**SUBJECT: NRC ACCEPTED VERSION OF IMPROVED BPWS CONTROL ROD INSERTION  
PROCESS LTR, NEDO-33091-A**

**NEDO-33091-A  
Revision 2  
Class I  
DRF 0000-0008-3745  
July 2004**

# **Improved BPWS Control Rod Insertion Process**

**SUBJECT: SAFETY EVALUATION FOR LICENSING TOPICAL REPORT (LTR)  
NEDO-33091, "IMPROVED BPWS CONTROL ROD INSERTION PROCESS"  
(TAC NO. MB9642)**

LIMERICK GENERATING STATION  
UNITS 1 AND 2  
UPDATED FINAL SAFETY ANALYSIS REPORT

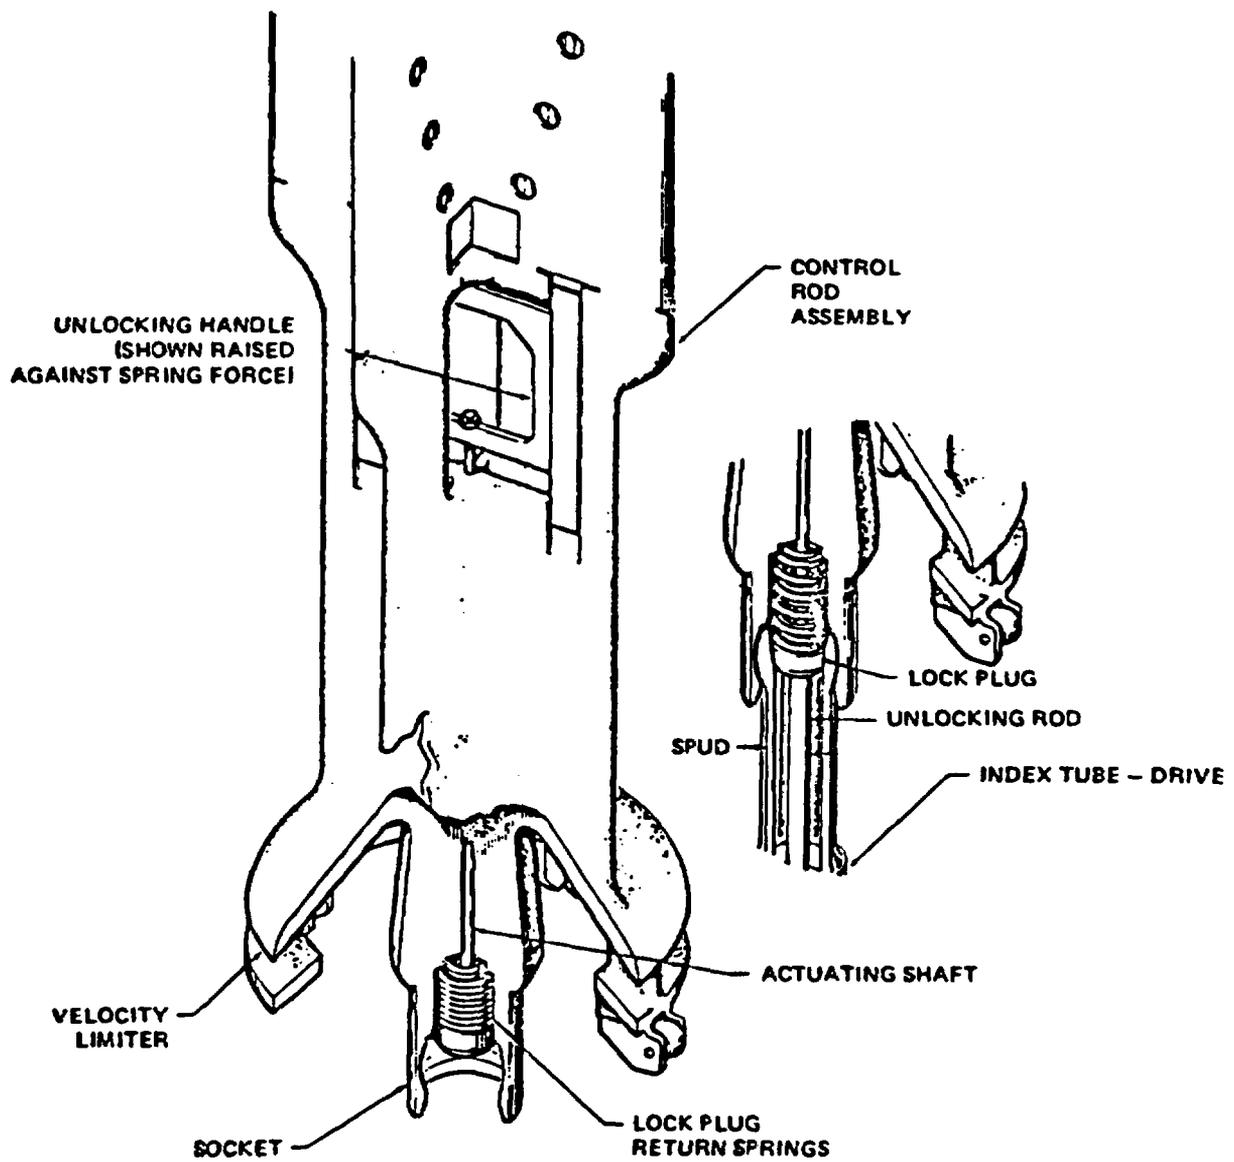
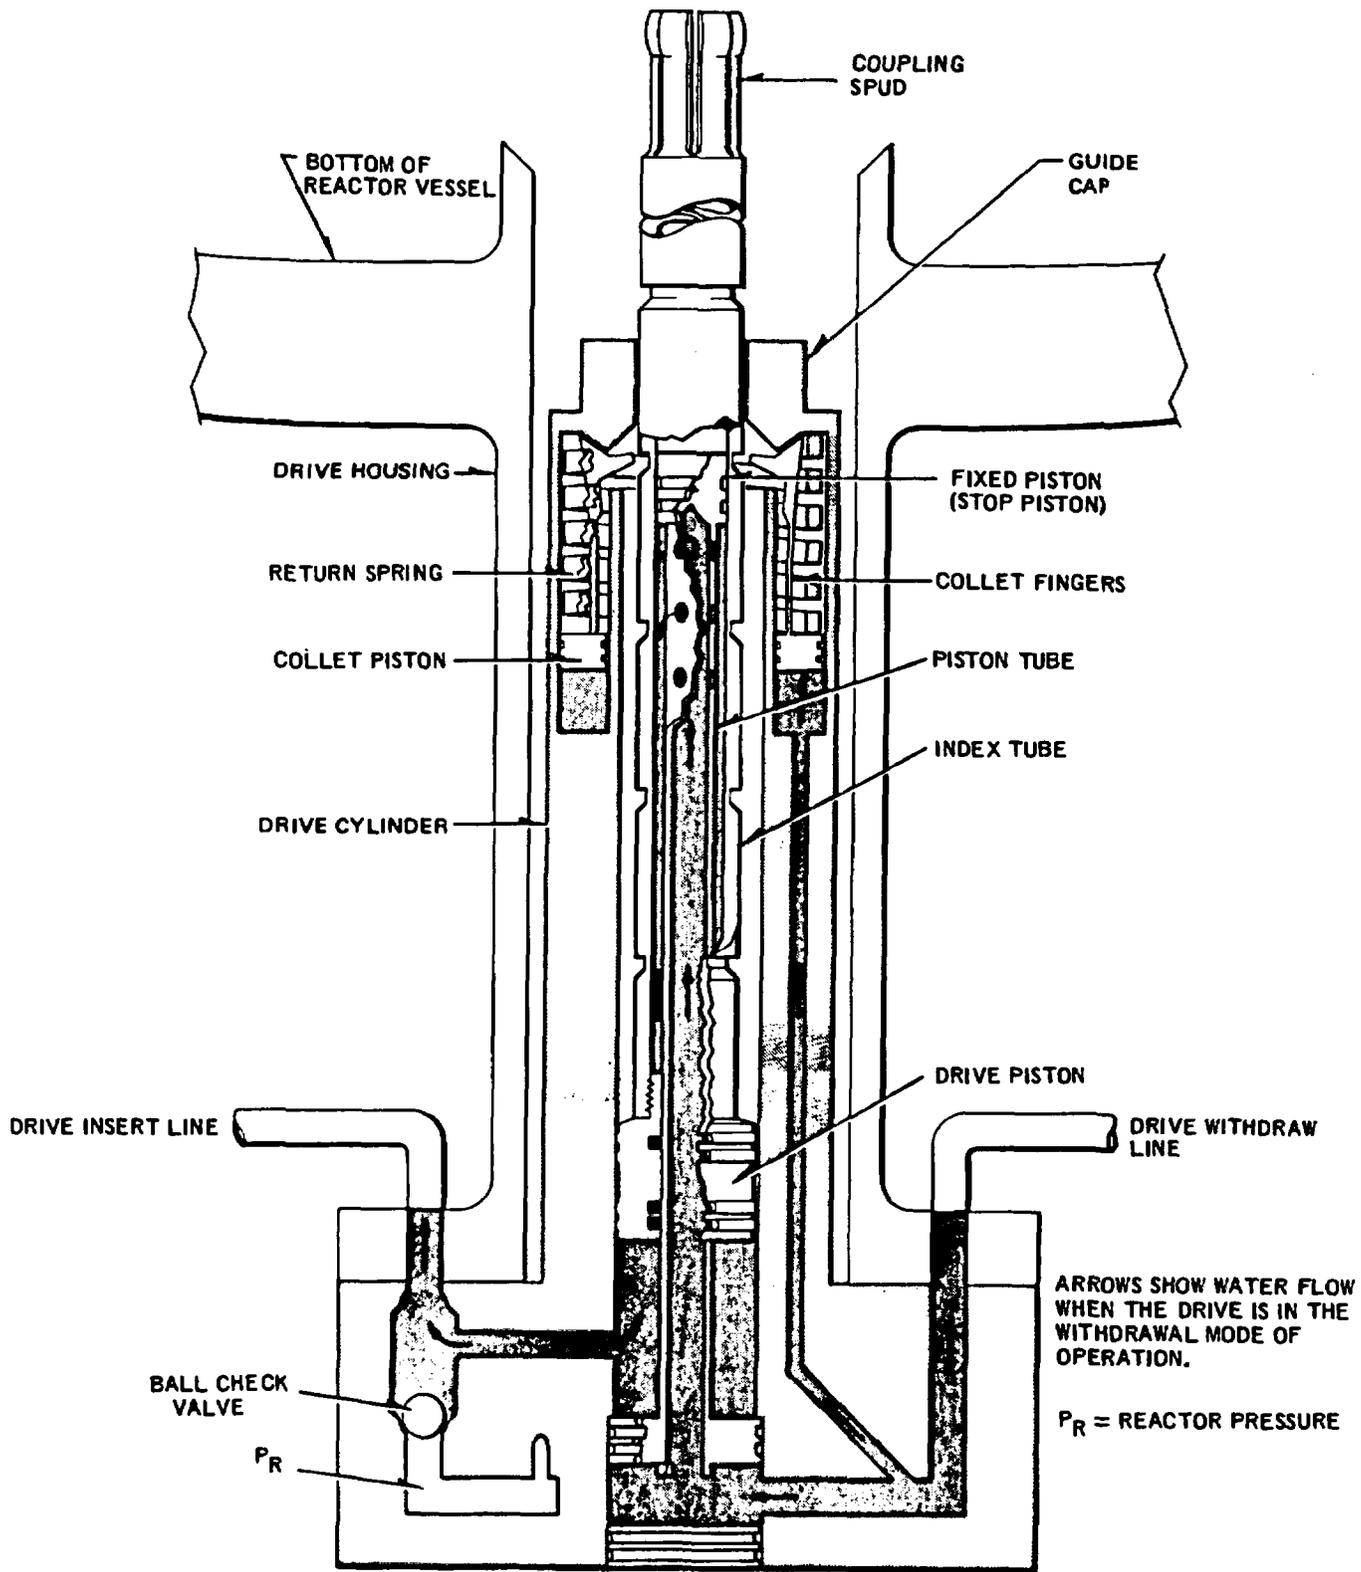
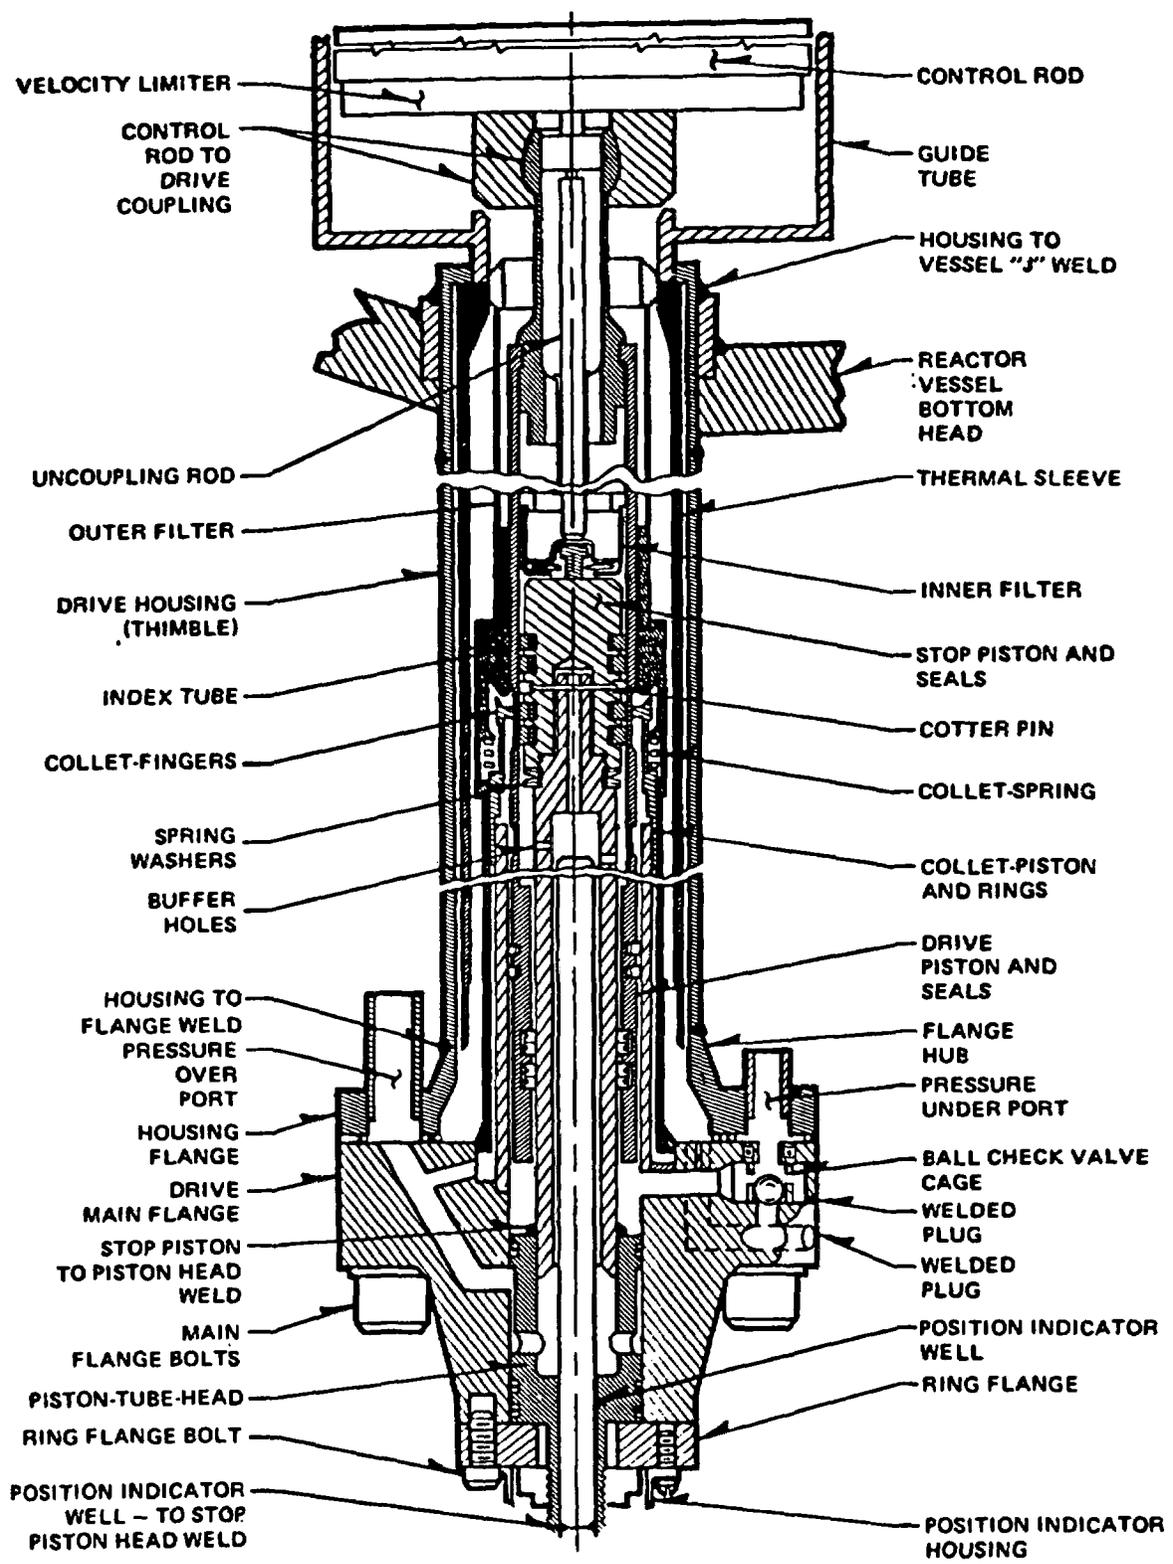
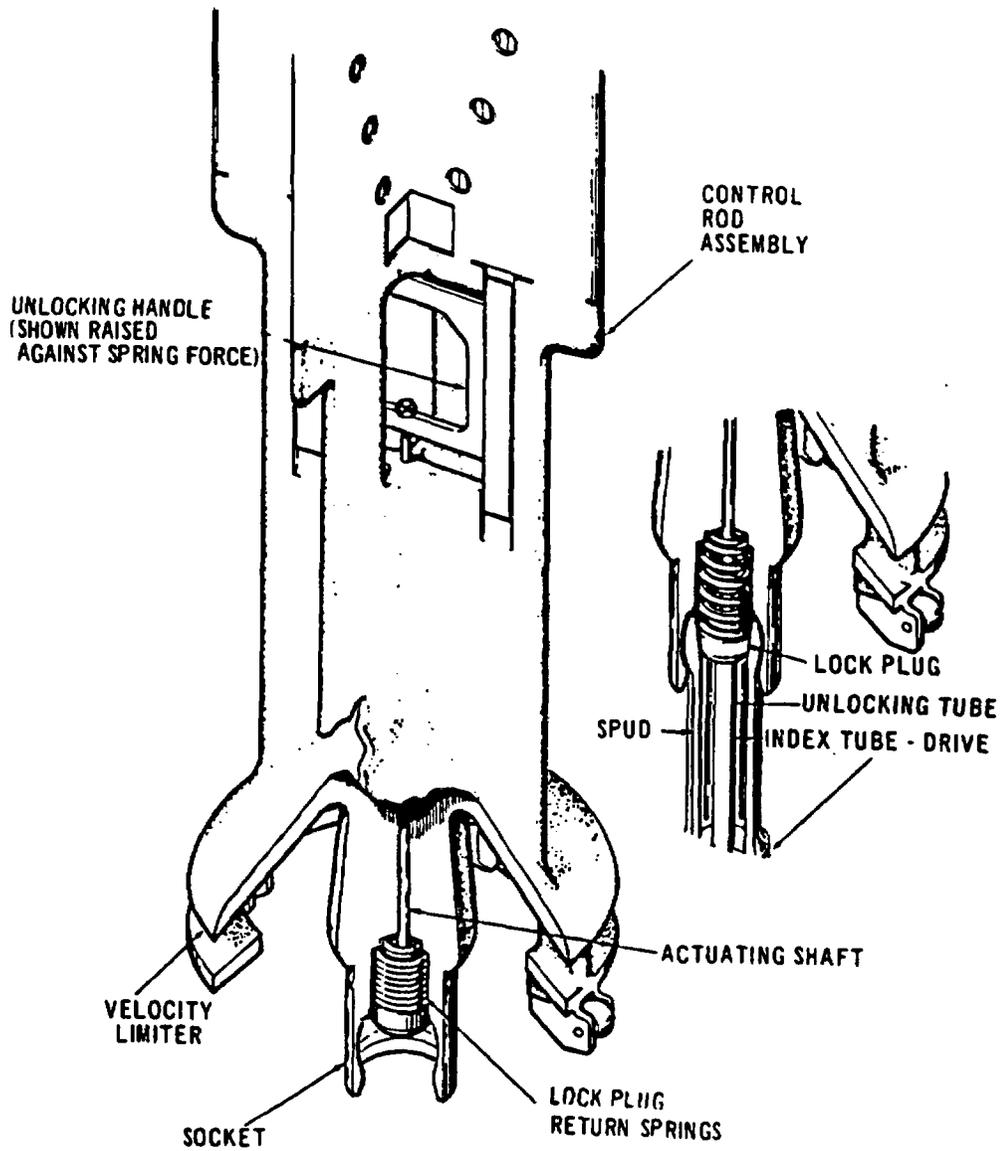
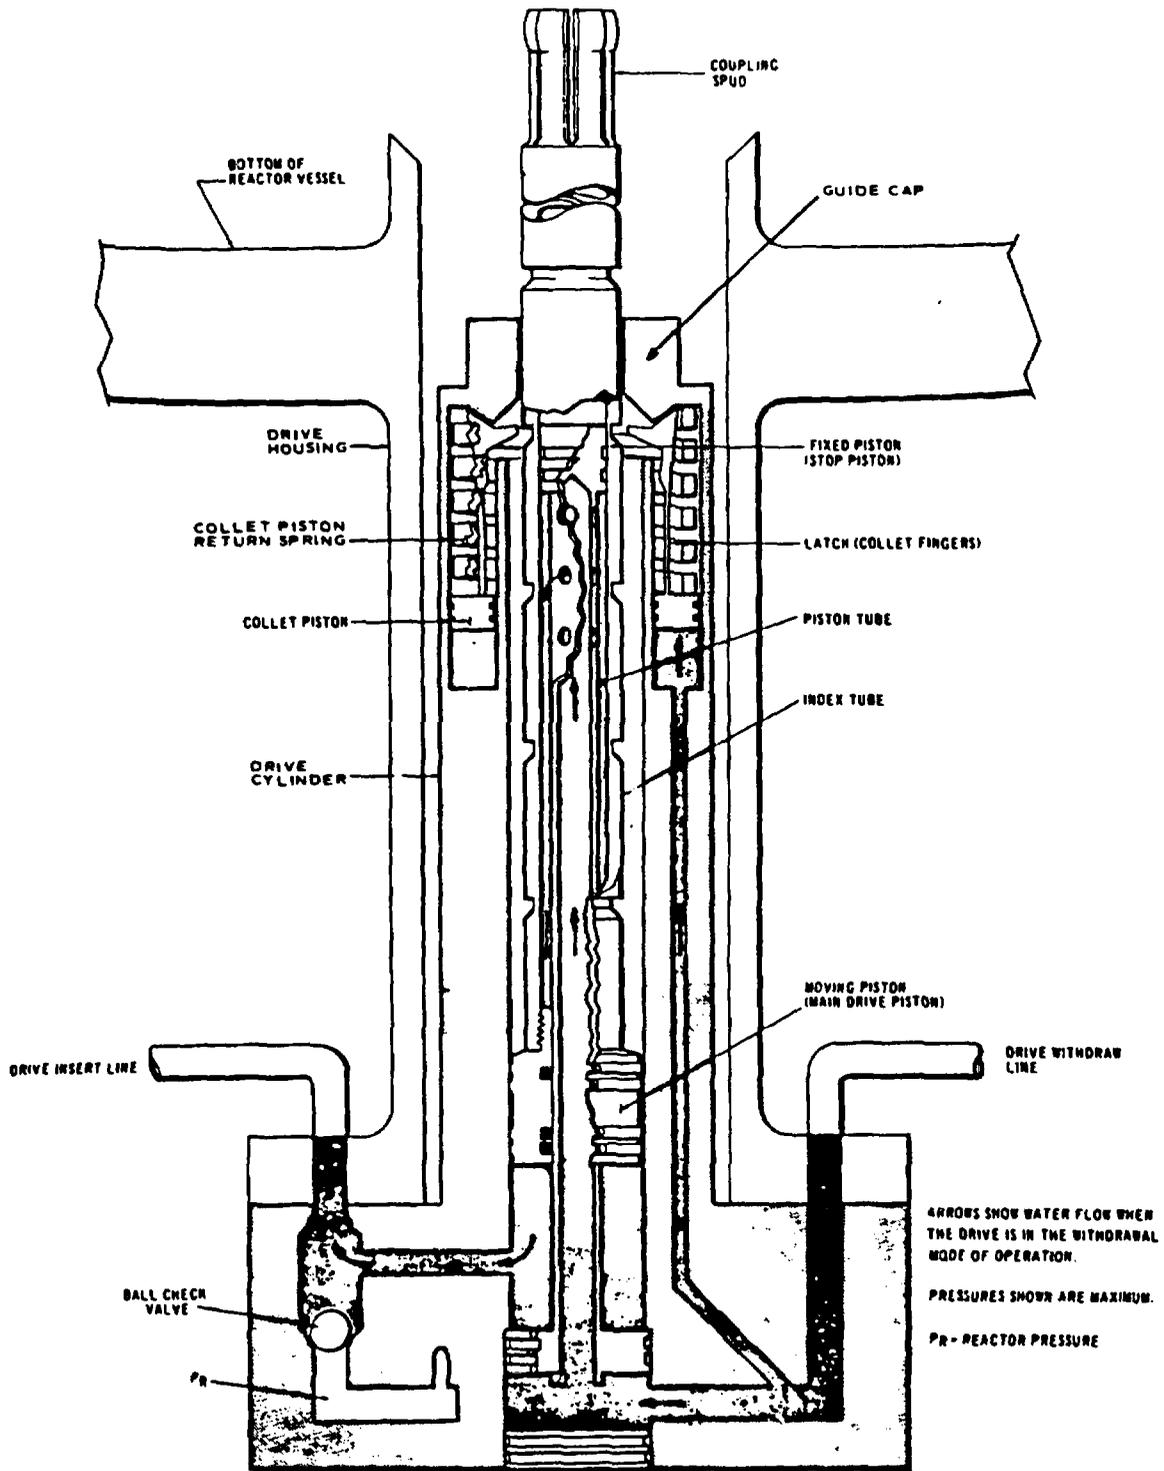
1. The LTR states that it is impossible for a control rod to become decoupled during the shutdown process following the improved BPWS. Please provide detailed information about the different types of control rod drives (CRDs) used for BWR-2 to BWR-6 plants with respect to the coupling between the CRD and control rod during shut-down. Based on this information, please also explain why it is not possible for the CRD and control rod to be decoupled.

All Reg. Guide 1.70, Rev.3 BWR UFSARs contain failure mode and effects analyses (FMEA) for the CRD system. Attachment 1 includes some pages from the FMEA in a typical BWR UFSAR (i.e., Limerick). As stated in the last paragraph of page 4.6-18, no single failure can of itself initiate a rod withdrawal. This statement is even more applicable, when the collet fingers are locked, such as when there is no CR movement or the CR is being inserted. (See Limerick Figure 4.6-3.) For a CR to withdraw, the six collet fingers must be unlocked so that the index tube can be lowered without being latched to a stop by the collet fingers. During CR insertion, if a mechanical/hydraulic failure occurs that stops all upward hydraulic force, the most the CR could withdraw is 6 inches to the next index tube latching indentation.

Attachment 1 also provides the UFSAR Control Rod Drive (CRD) and Control Rod (CR) design figures for a BWR/2 (Oyster Creek), BWR/3 (Monticello), BWR/4 (Limerick), BWR/5 (La Salle) and BWR/6 (Perry). For all BWR/2-6 plants, these figures demonstrate that a CR sits atop its associated CRD, and that it is physically impossible for a CR to move down past (i.e., to be withdrawn) its CRD.

Normally, a CR cannot become uncoupled from its CRD, because the CRD spud ("6-fingers") mechanically locks into the CR socket, and operator action is required to unlock this coupling. It is possible, due to a CRD assembly error, for a CRD to not properly lock into CR. In this case, CR movement (withdrawal and insertion) and scram are not impaired, because gravitational force will maintain the CR on top of its CRD. Plant Technical Specifications already provide provisions for coupling checks and steps to be taken if a CR is uncoupled from its drive.
